## **ADDENDUM 002**

# ORANGE BEACH JUSTICE CENTER RE-ROOF REQUEST FOR INFORMATION LOG

SHEET NUMBER:  
**AD101.2**

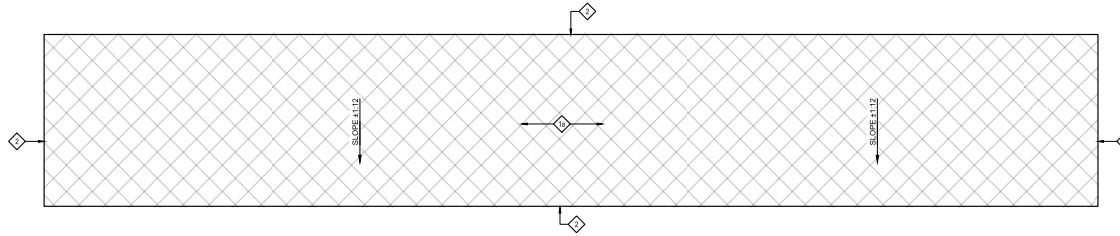
Add sheet in its entirety to include demolition of existing 12’ x 12’ (Contractor to verify) “smokers pavilion” and existing 145’ x 30’ (Contractor to be verify) lean-to and animal control shed on the northeast corner of the property to the Documents.

SHEET NUMBER:  
**A101.2**

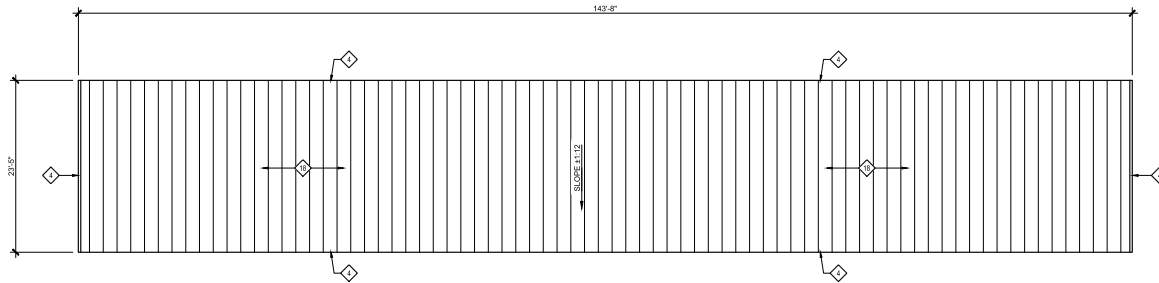
Add sheet in its entirety to include re-roof of existing 12' x 12' (Contractor to verify) "smokers pavilion" and existing 145' x 30' (Contractor to be verify) lean-to and animal control shed on the northeast corner of the property to the Documents.
